SUBJECT: Technical Assistance Request - Review of Site Investigation and Response Action Plan
Enbridge Energy Superior Terminal (Facility Wide), Superior, WI
WDNR BRRTS Activity #: 02-16-560657

On June 27, 2013, you requested that the Department of Natural Resources ("the Department") review and approve a Site Investigation and Response Action Plan, Proposed Risk-Based Site Wide Approach, prepared by Barr Engineering. The purpose of the submittal is to provide the technical basis for a proposed negotiated agreement that would result in the use of a performance standard as a remedial action to address the groundwater pathway for releases at the Superior Terminal.

Figure 15

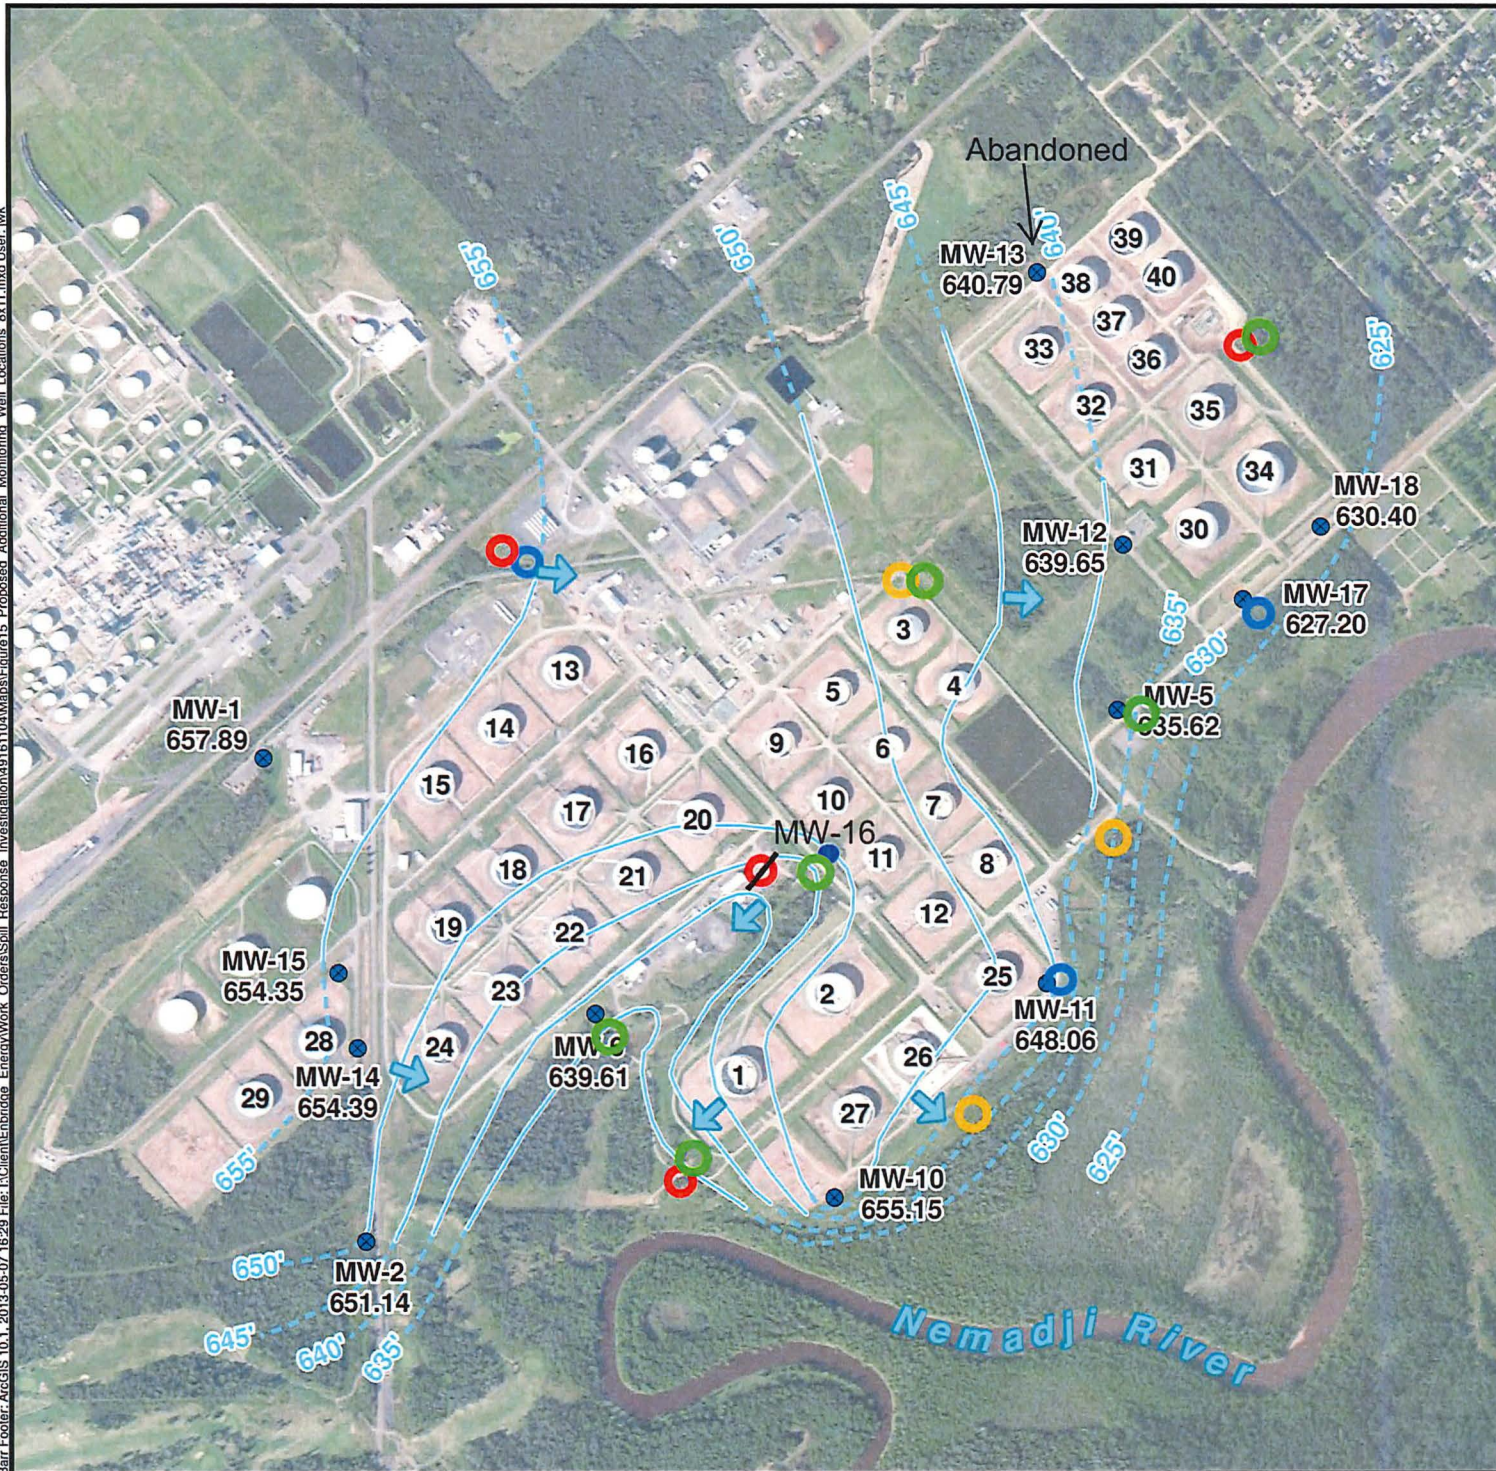
- For any figures depicting the site monitoring wells, please provide corrected maps by removing MW-13 (recently abandoned) and adding MW-16 (not depicted on previous figures).

- Proposed Groundwater Monitoring Program (Section 1.5 and Appendix E) –
 - Given the size of the facility, and the potential for releases anywhere on the facility, additional wells are required to confirm the presence or absence of groundwater impacts. We would like to request additional wells to define both the horizontal and vertical extent. Please add additional monitoring wells in the locations depicted on the attached map.

- Please overlay the Terminal Property Boundary on Figure 15.
 - Modify sampling parameters for all monitoring wells to include PVOCs and Naphthalene instead of BTEX and DRO.

DNR Revisions
